BCA Assessment Report

38 Park Street & 1793 – 1797 Pittwater Road, Mona Vale

Project: 38 Park Street & 1793 – 1797 Pittwater Road, Mona Vale
Reference No: 111006-BCA-r3
Date: 17 September 2020
Client: Mona Vale 3 Pty Ltd & 1793 Pittwater Road Pty Ltd
Client Contact: Sean Gartner
Email: sean@g-t.com.au
BCA Logic Contact: Warwick Hunter
Direct: 8484 4077
Email: whunter@bcalogic.com.au

Figure 28 in AS 1428.1:2009

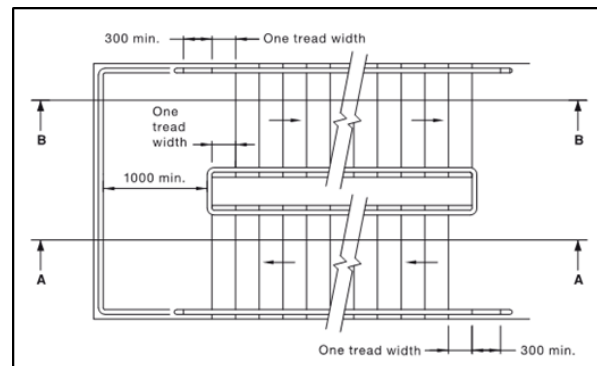
Note: The handrail to the main residential non-fire isolated stair currently extends up continually around stair flights and landings and to the top landing. The issue with this design is that the handrail is to be in the range 865-1000mm throughout stair flights but more than 1000mm where landings are more than 500mm
